ADDENDUM NO. 2

PROJECT: NW Connell and NW Garibaldi Street Improvements, No. 10485

DATE: June 27, 2013

This addendum to the contract documents is issued to clarify, correct, and supplement the drawings and contract documents issued as "NW Connell and NW Garibaldi Street Improvements", bid closing date July 2, 2013.

SHEET NO.
C-102

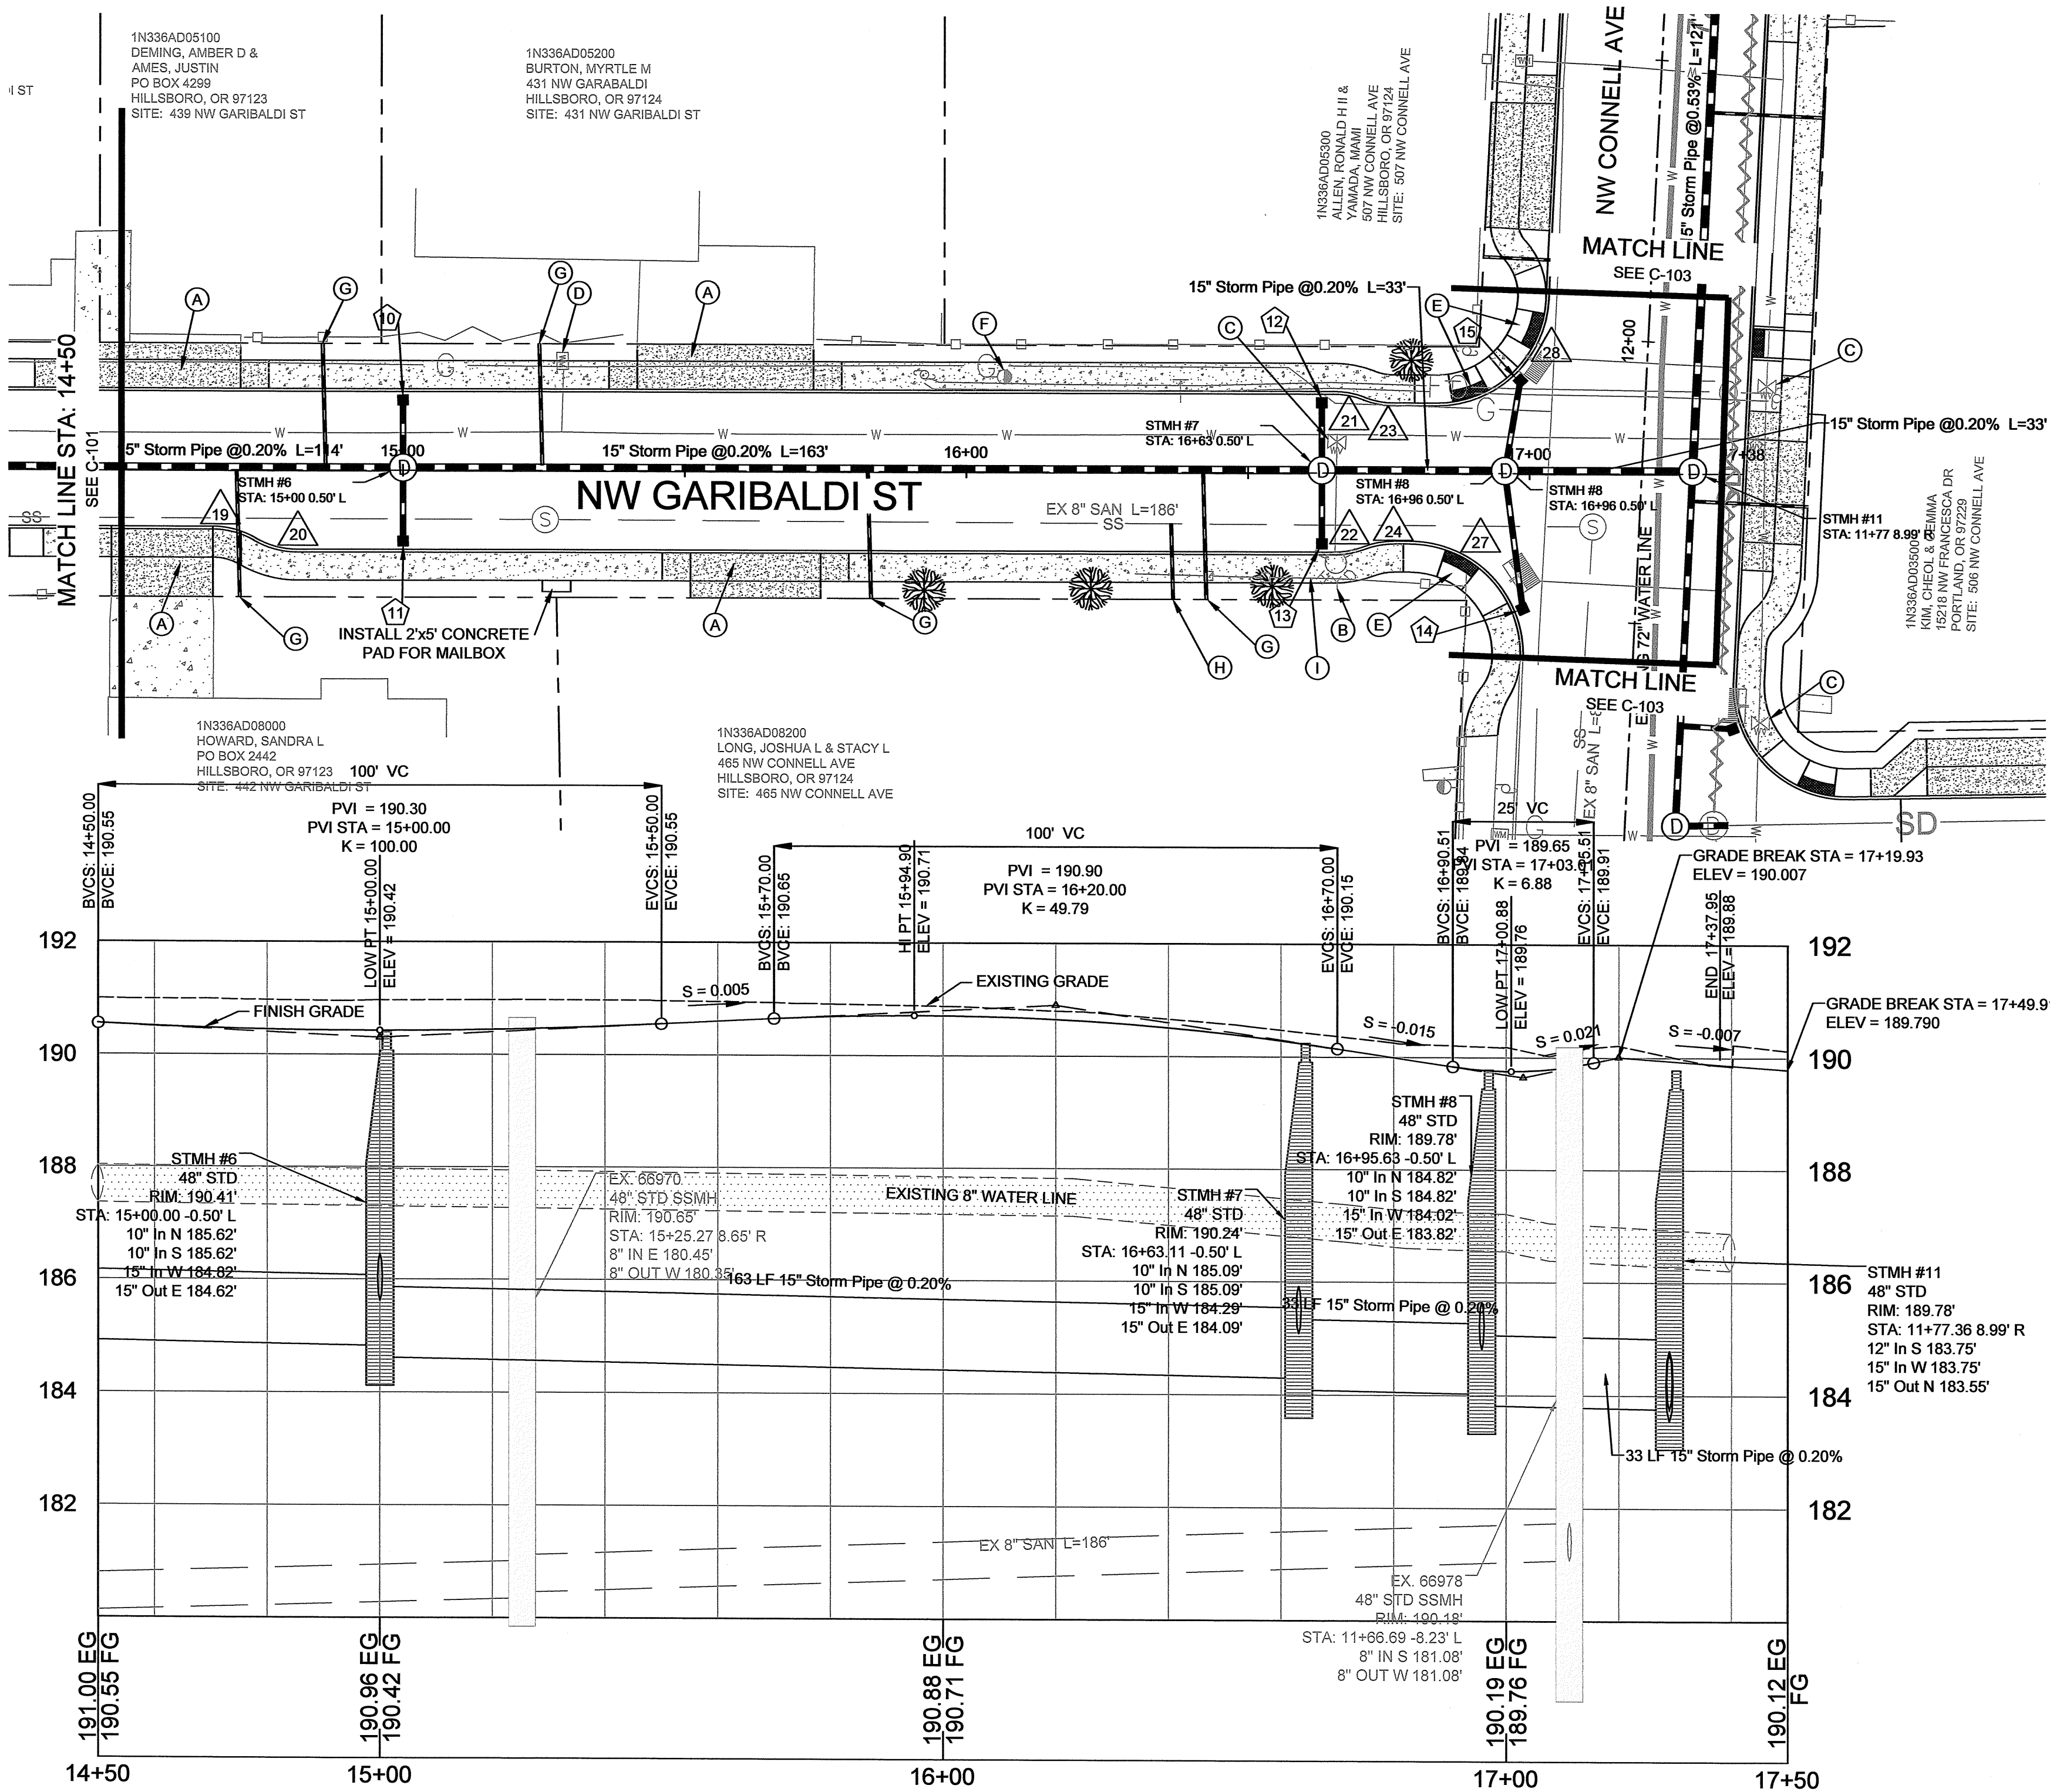
Page C-102 (16 of 32)

1. All Catch Basin Runs should be 10" C-900 pipe.

SHEET NO. **C-103**

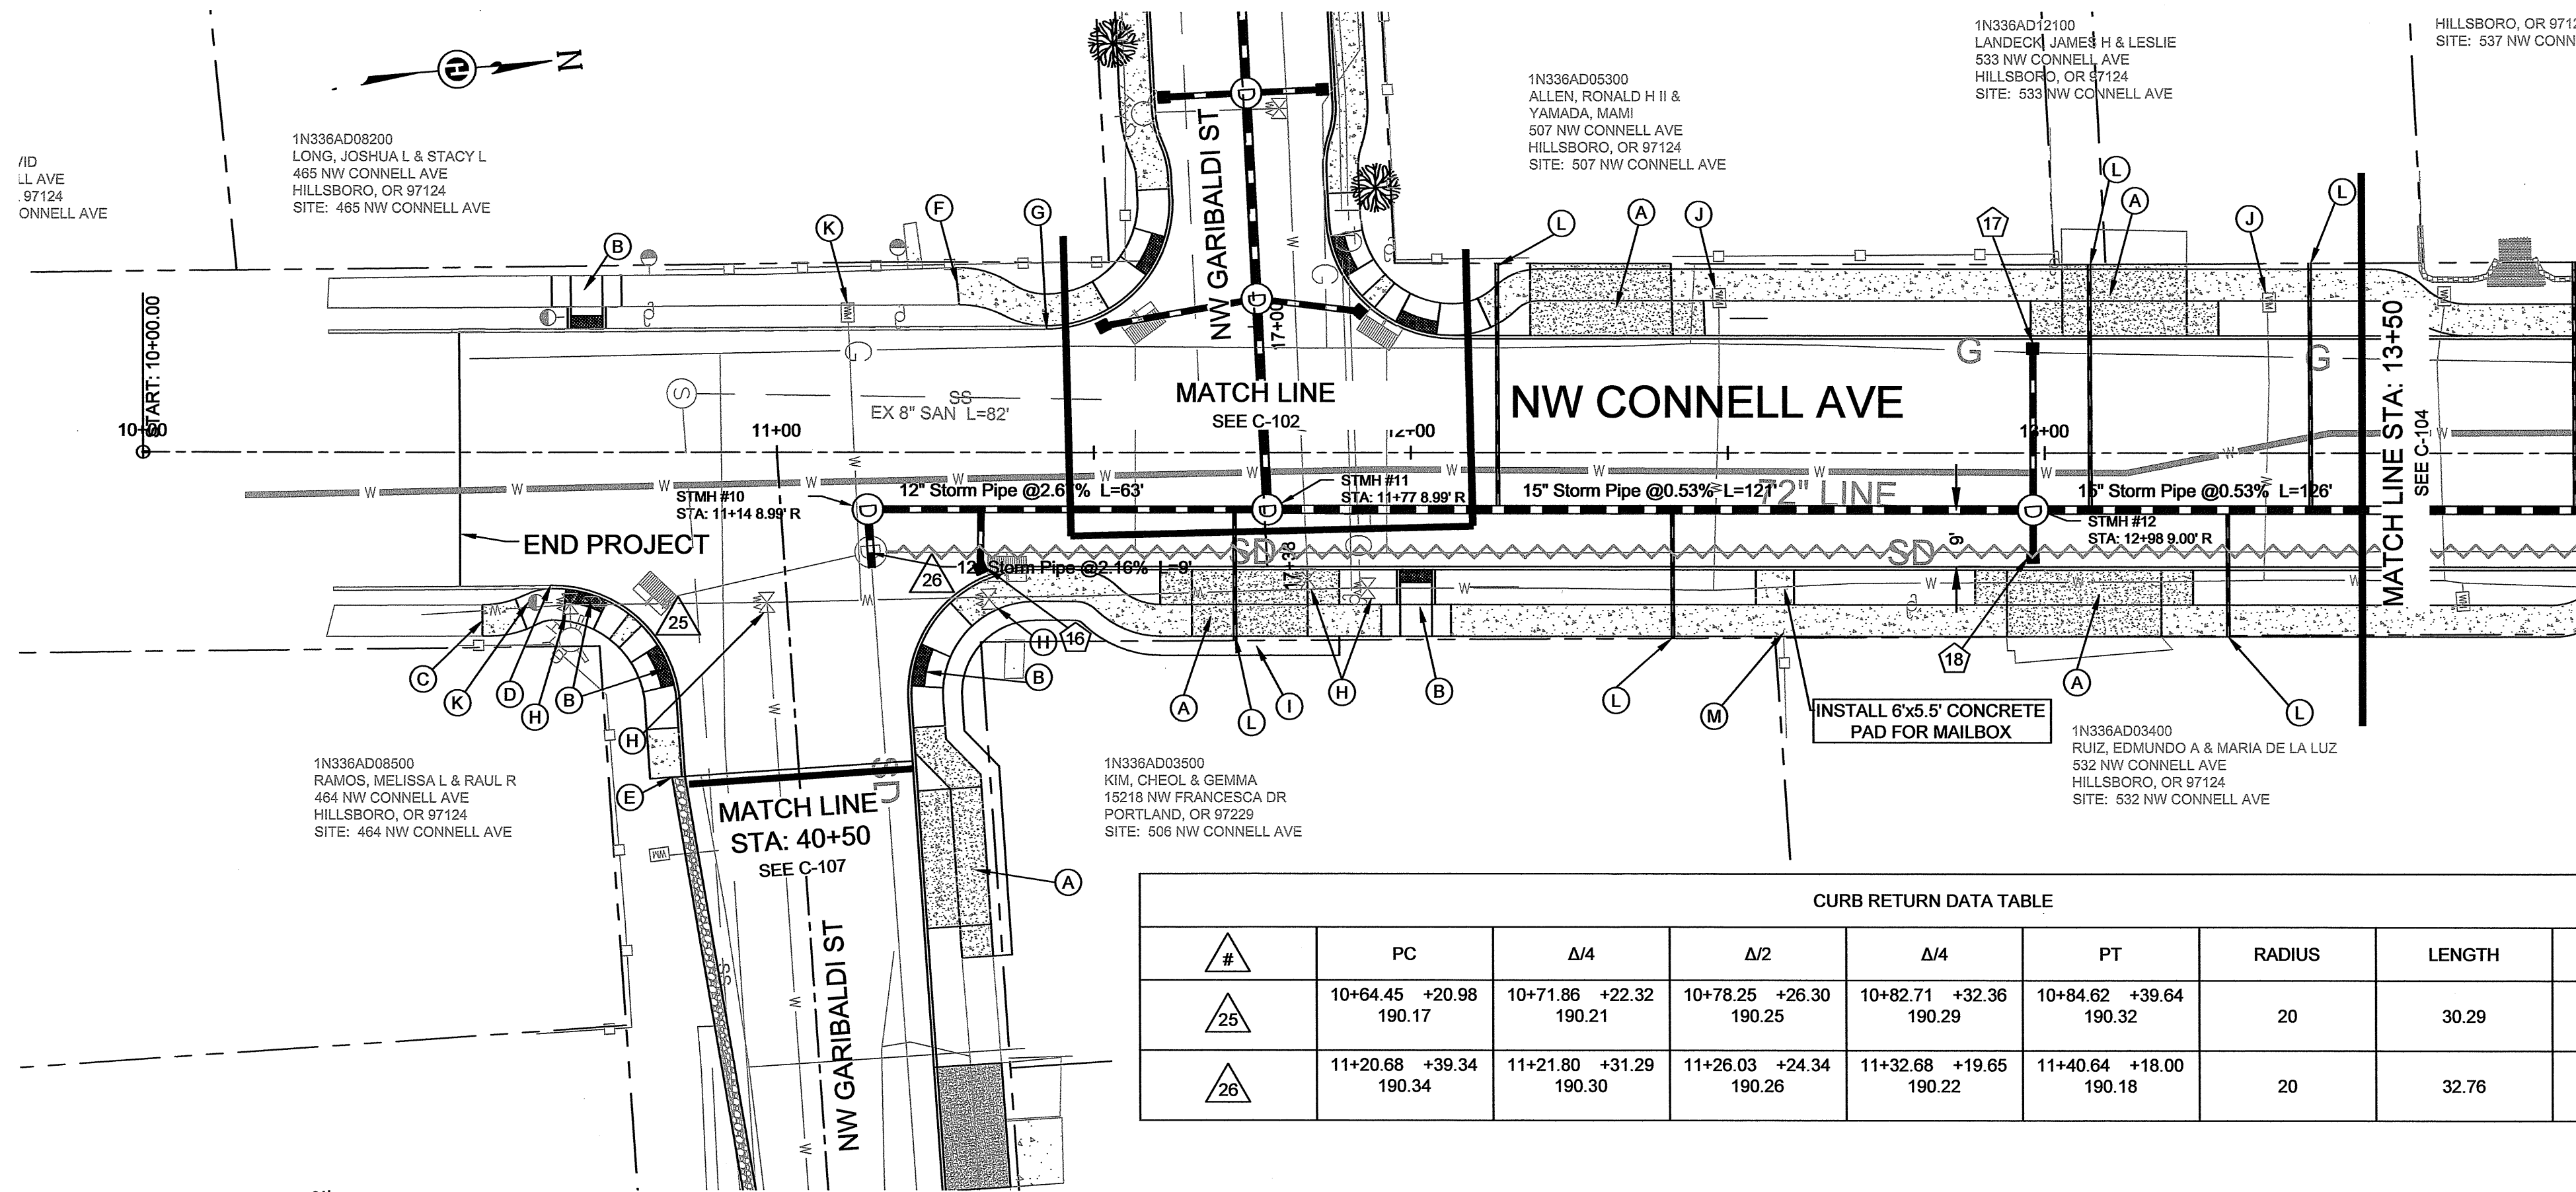
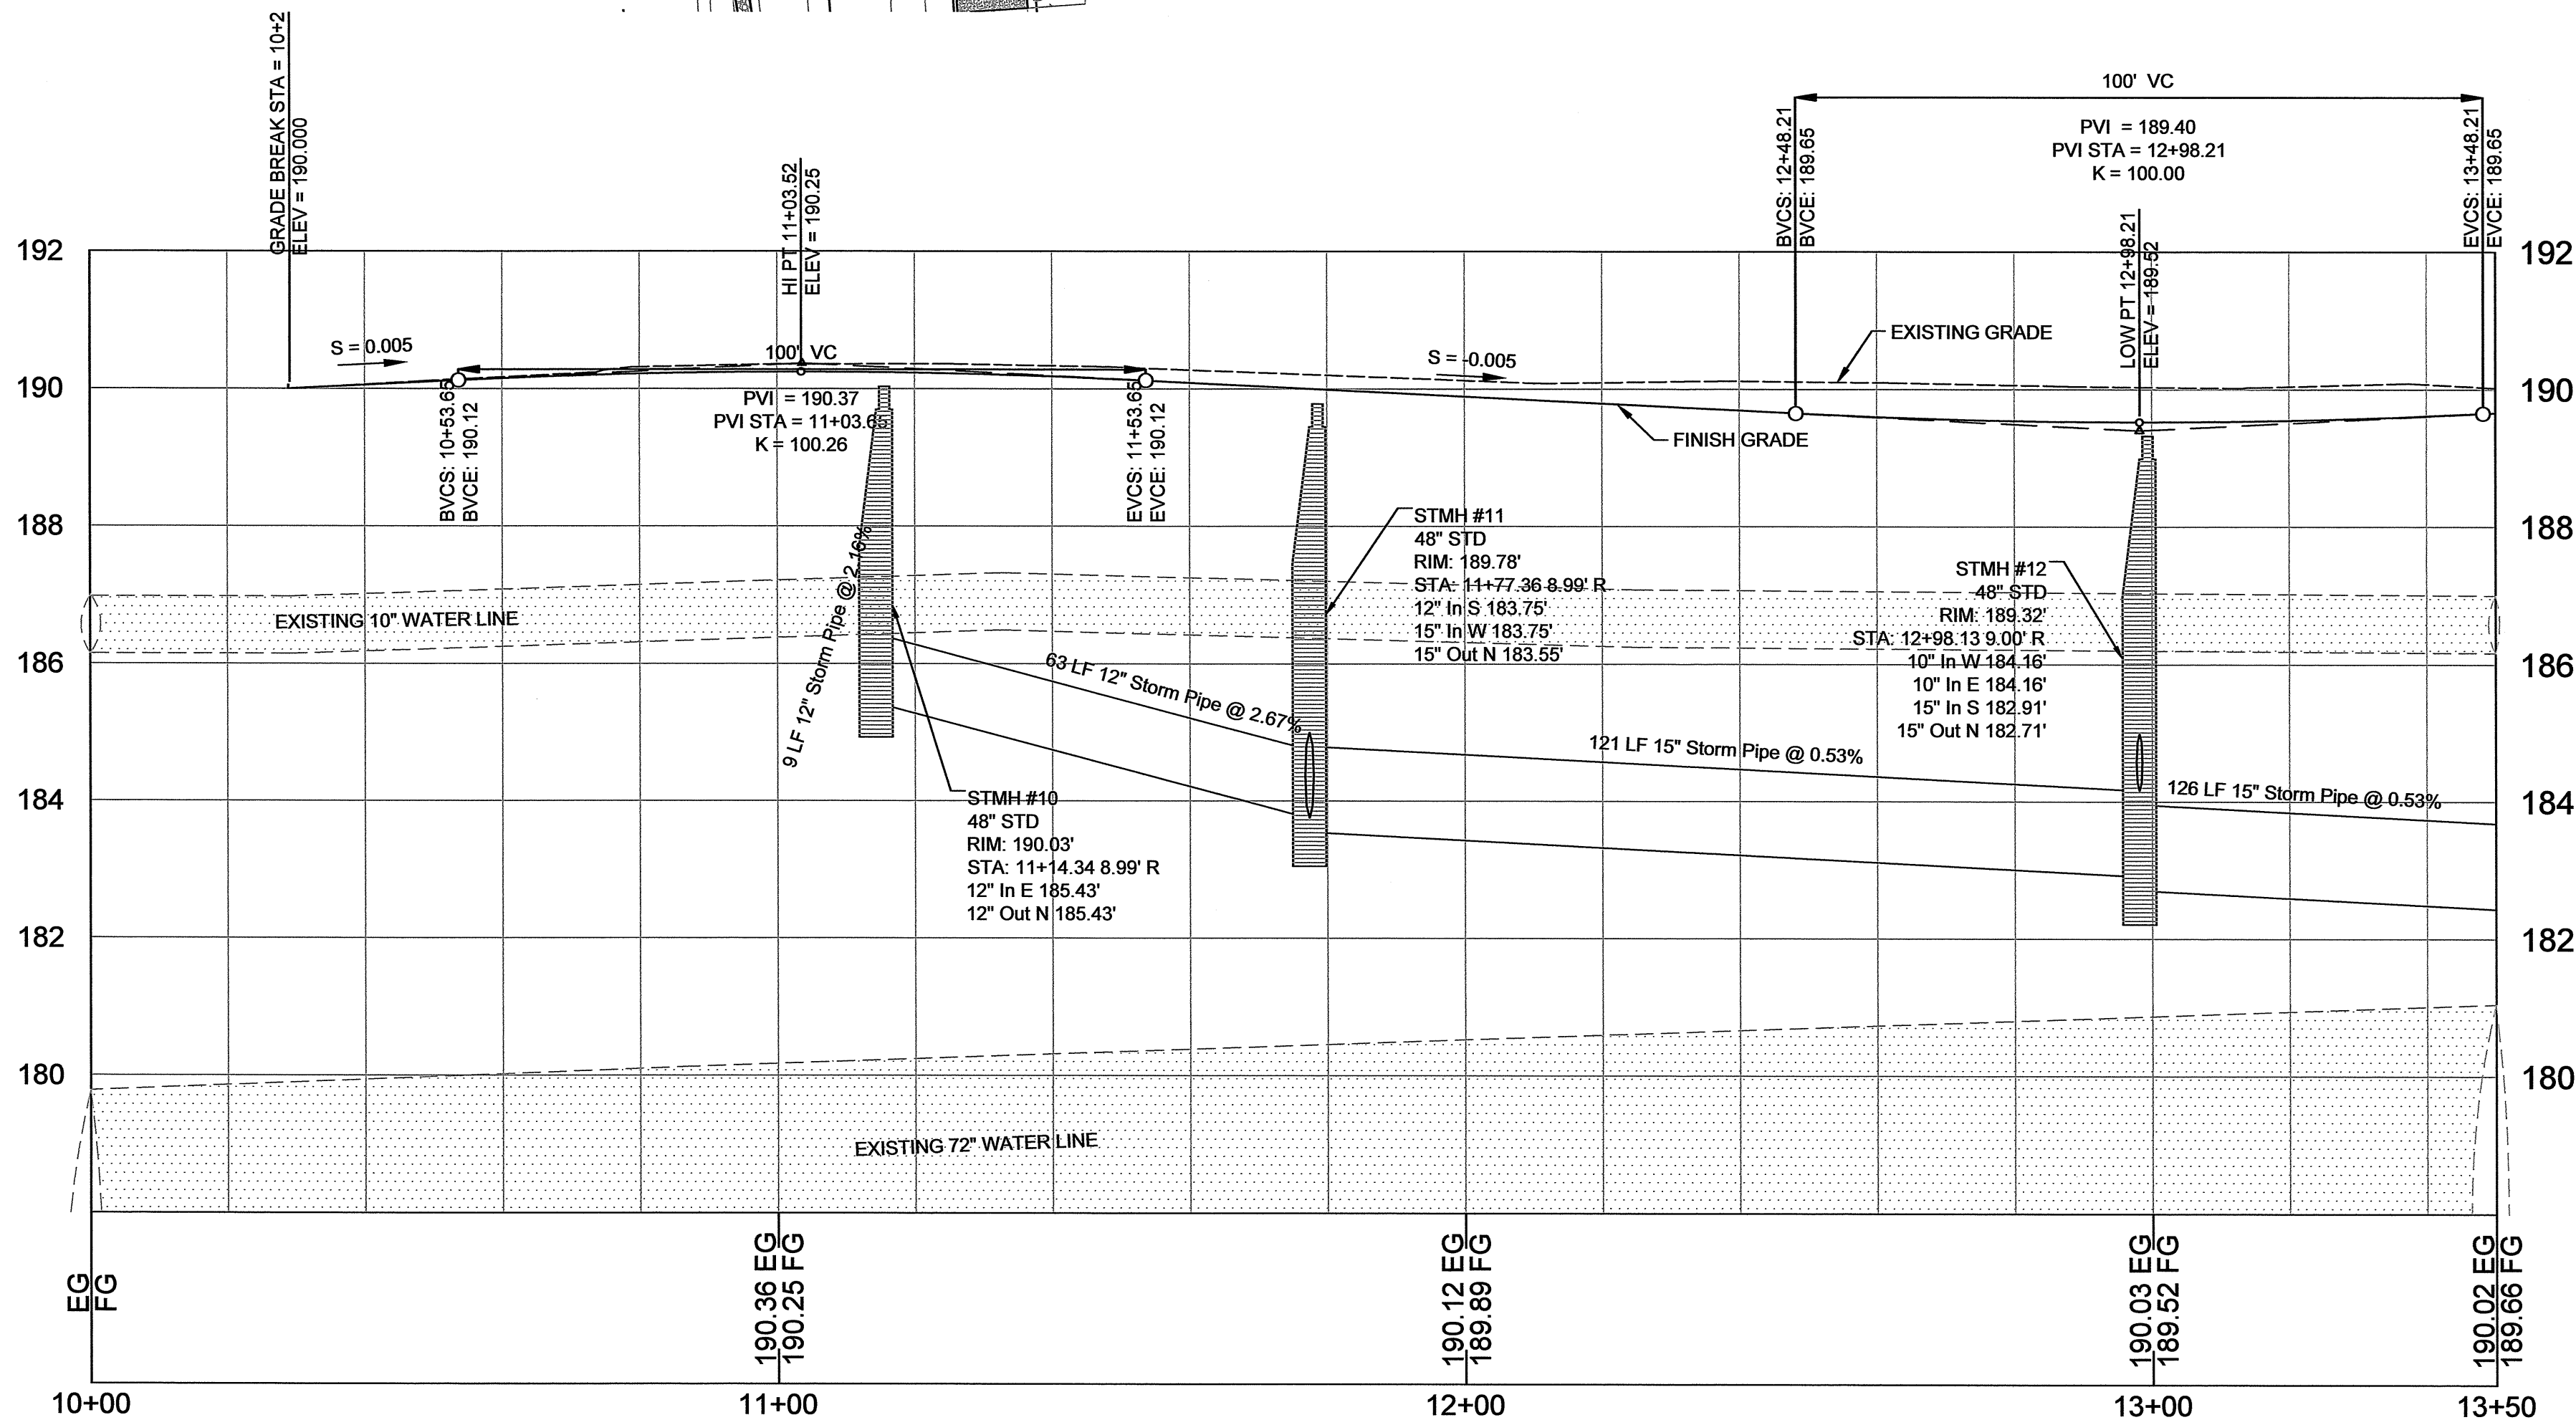
Page C-103 (17 of 32)

1. All Catch Basin Runs should be 10" C-900 pipe.
